VILLAGE OF GERMANTOWN
N112 W17001 MEQUON ROAD
GERMANTOWN, WI 53022

MEETING:	PLAN COMMISSION
DATE AND TIME:	MONDAY, September 24, 2018 6:30 p.m.
LOCATION:	Germantown Village Hall Board Room

9/24/18 Plan Commission Meeting

SITE PLAN REVIEW

SITE PLAN
SCALE: 1"=30'

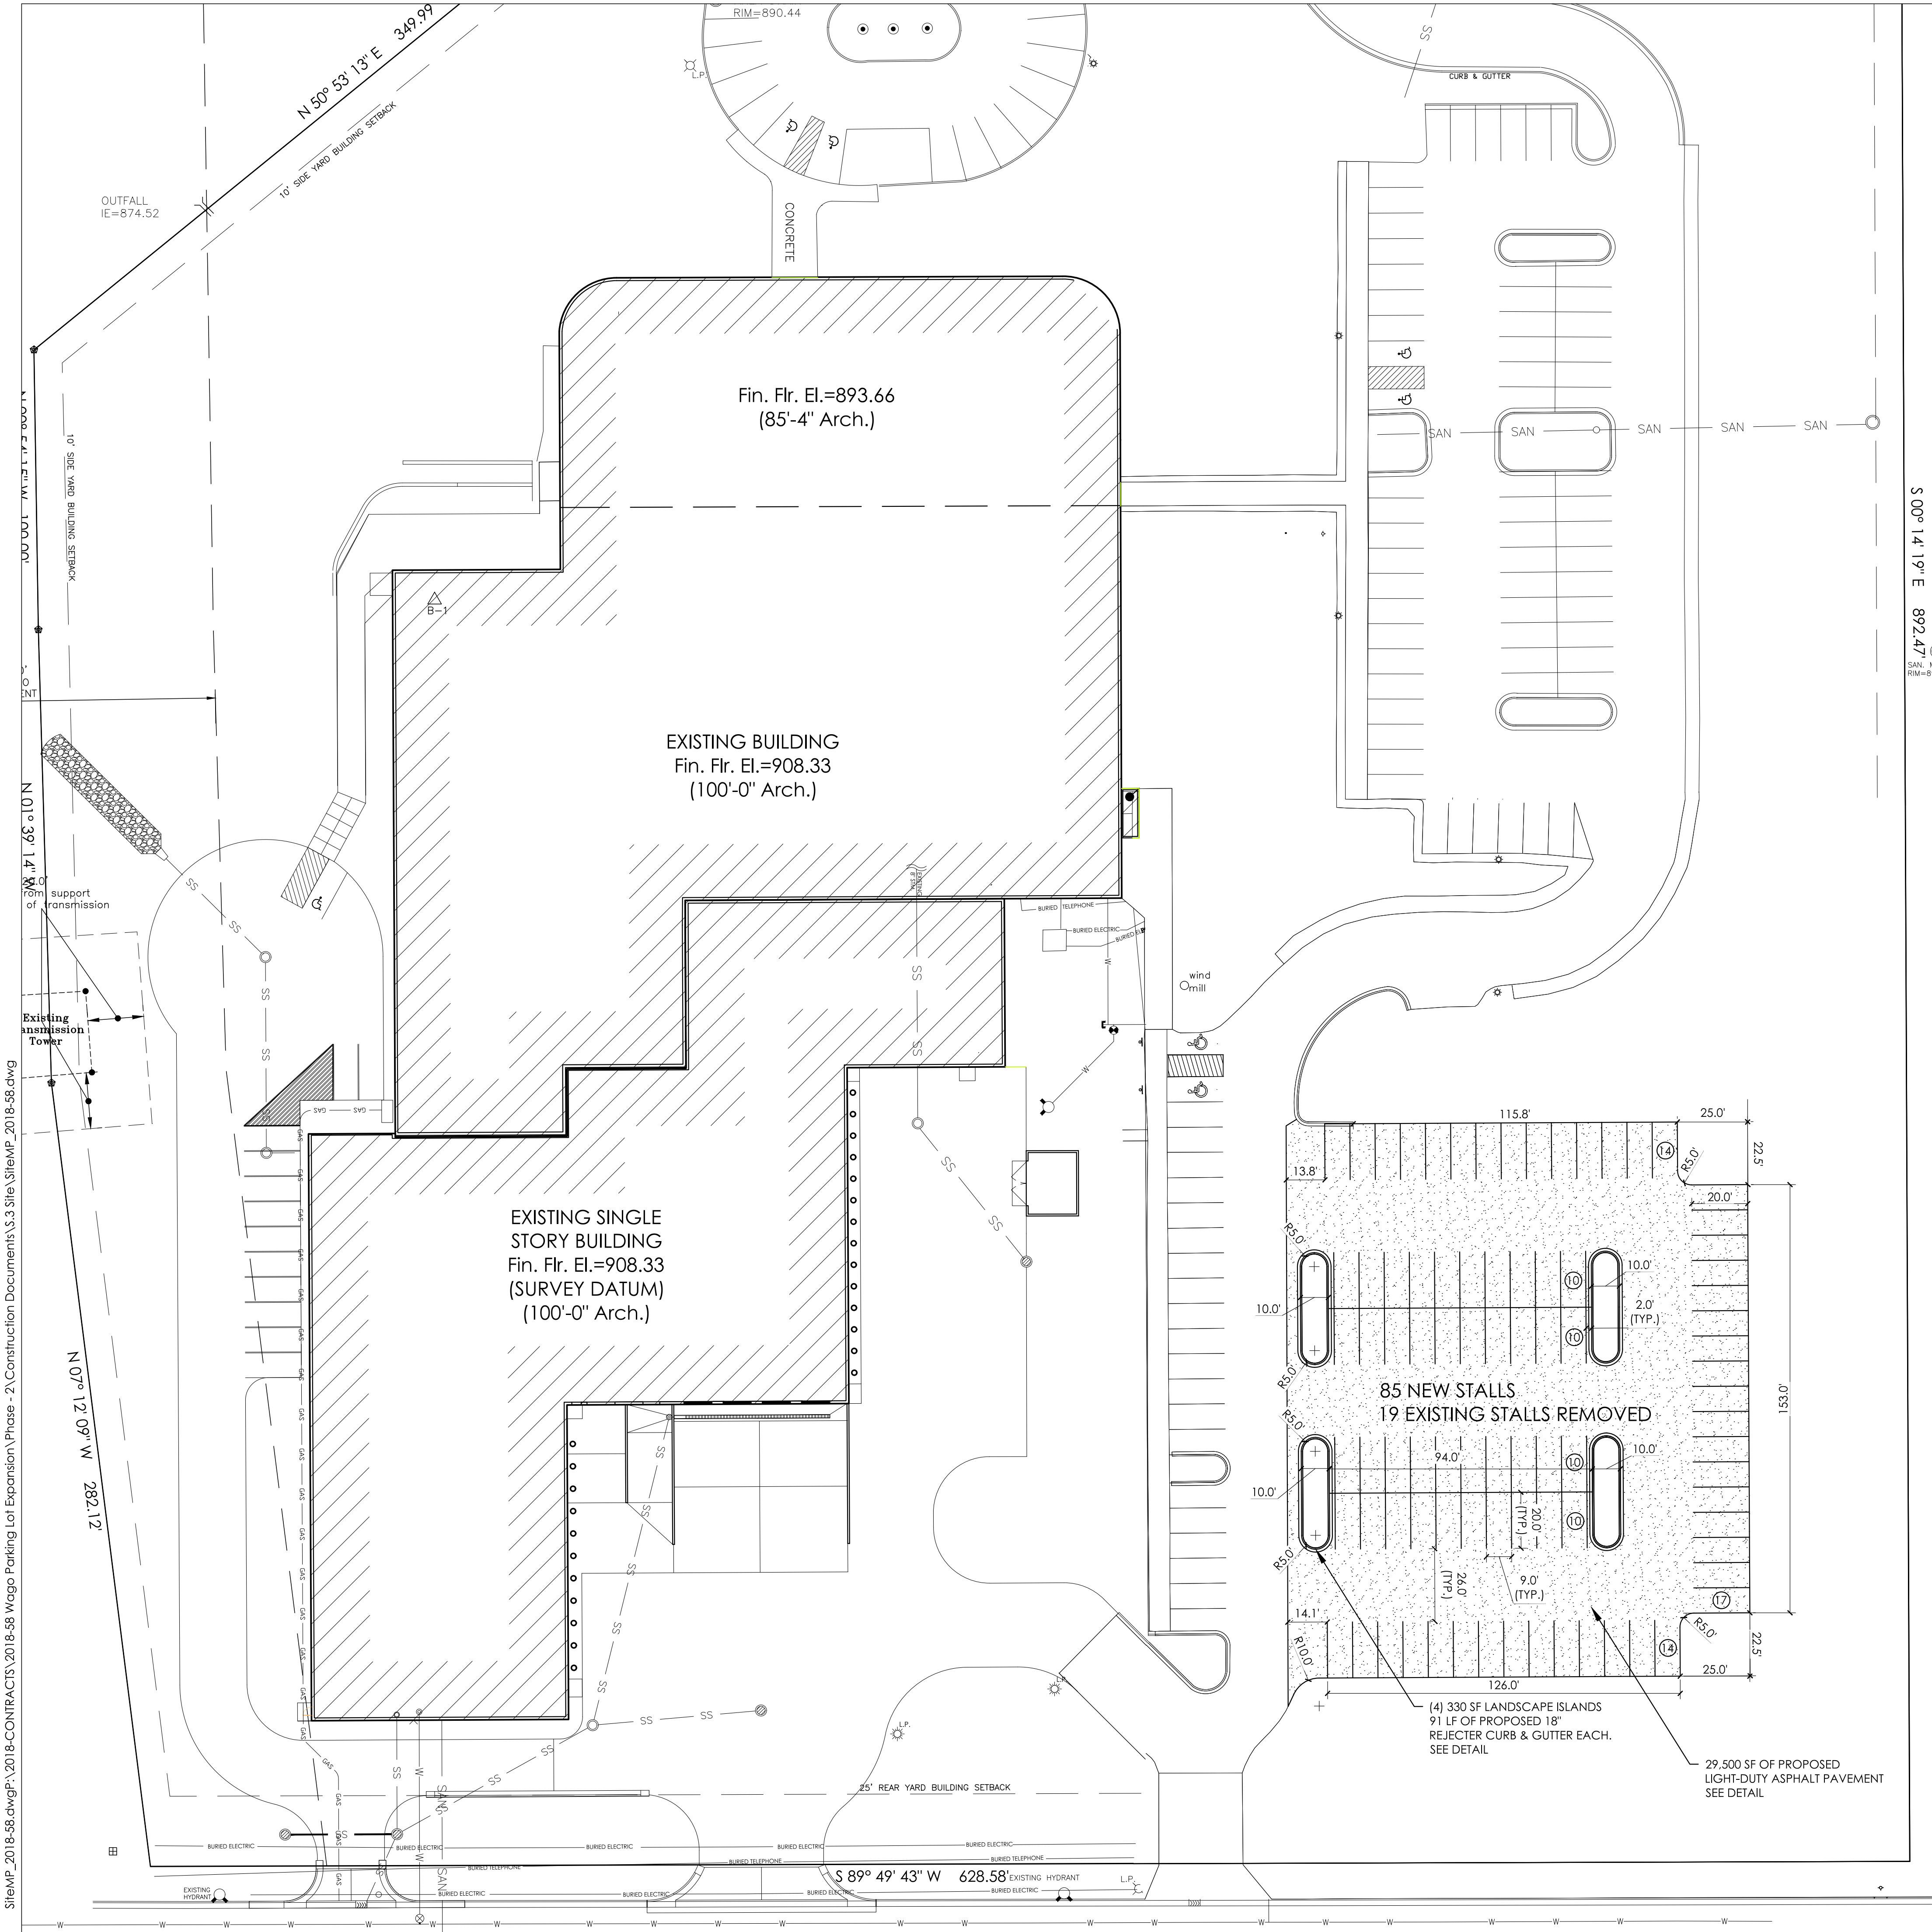
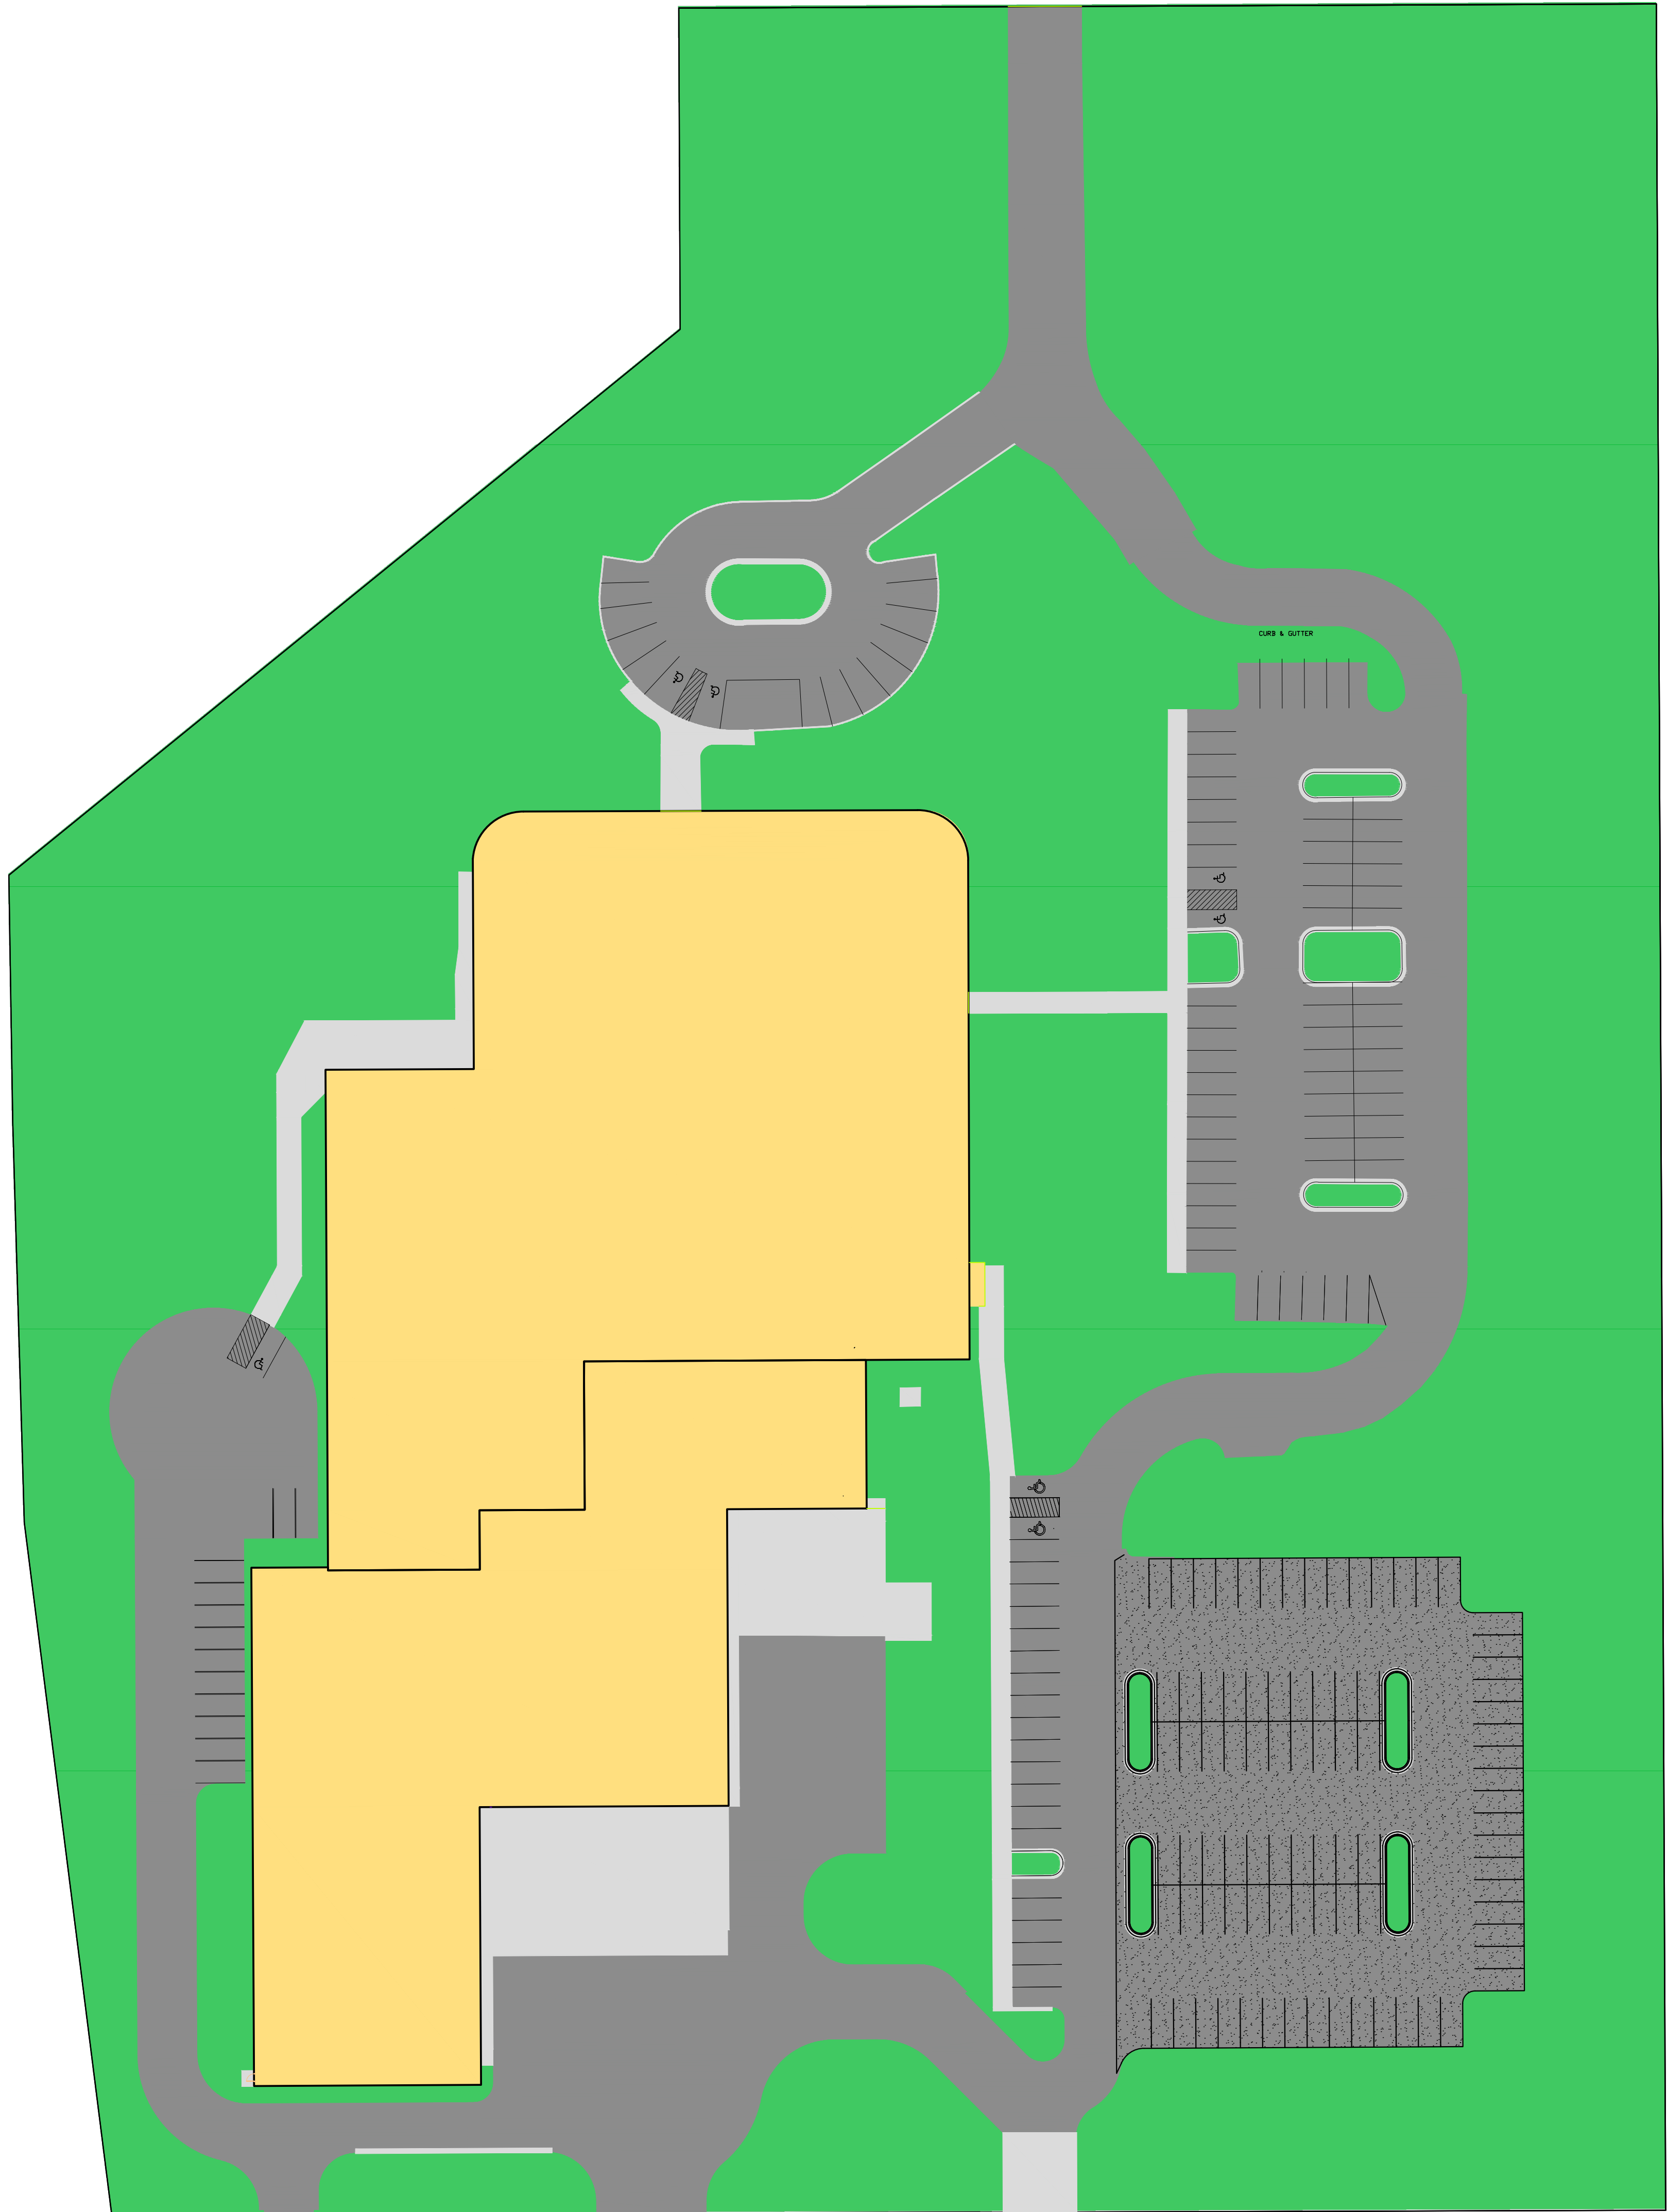
An erosion control plan should be developed and submitted for engineering review, including the following:

- Temporary erosion control measures should be called out in the plan if stabilization requirements are not met prior to the onset of winter.
- The proposed silt fence should be “hooked” at the ends to prevent bypass flow.
- The plans are to be signed and stamped by a professional engineer.

There are two sections of sidewalk along Freistadt Road that Wago is responsible for removing and replacing as part of this project. The concrete slabs are located in Wago’s driveway that accesses Freistadt Road.

4. An erosion control plan shall be developed and submitted to the Village for engineering review prior to commencement of construction. Said plan shall include the following:

- Temporary erosion control measures should be called out in the plan if stabilization requirements are not met prior to the onset of winter;
 - The proposed silt fence should be “hooked” at the ends to prevent bypass flow;

- The plan shall be signed and stamped by a professional engineer.
5. The owner shall remove and replace two sections of sidewalk along Freistadt Road as part of this project. The concrete slabs are located in Wago’s driveway that accesses Freistadt Road.

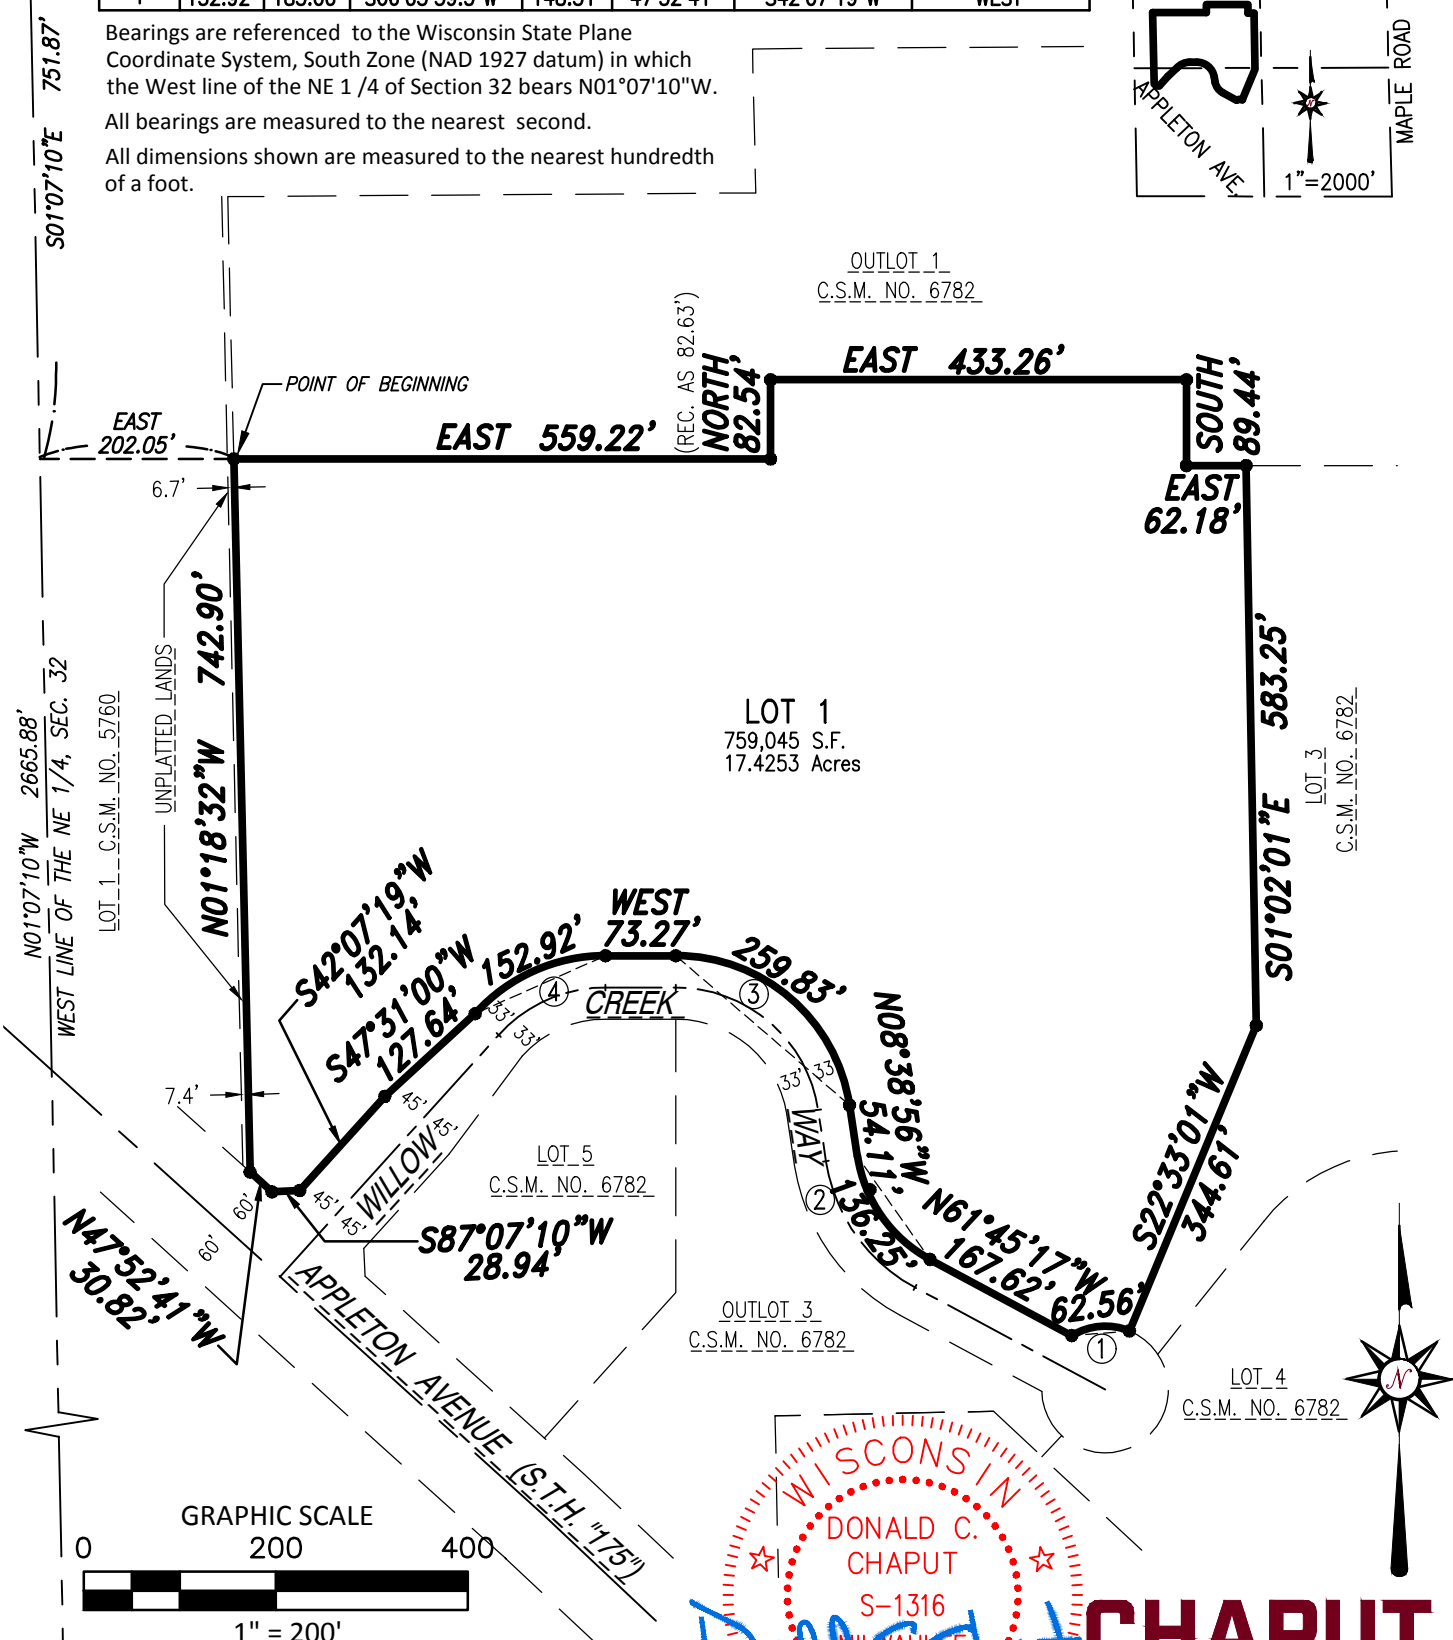
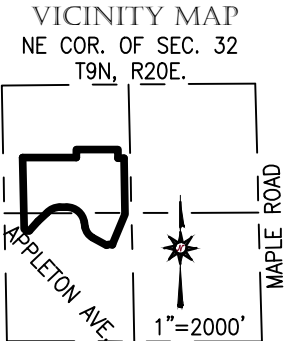
4. On sheet 2 of 5, please add the missing easement dimensions and bearings (or use a line table if space is an issue) for the drainage easement that is located on the west side of the property. The dimensions are on the south end of the easement.

5. On sheet 2 of 5, either continue the building setback lines along the north and east side of proposed Lot 1, parallel with the proposed boundary exhibit or add the existing TransCanada and ATC utility easement lines and widths and a note stating that no buildings are allowed within the existing utility easement area.

6. On sheet 2, there is a small wetland area shown. There needs to be a note added stating who did the wetland delineation and who mapped the wetland lines. This area is also missing the 25' buffer line that is offset from the delineation line.

7. There is an existing building on proposed Lot 1 that needs to be added to sheet 1 with offset dimensions to the exterior boundary on the front and closest sideyard offset.
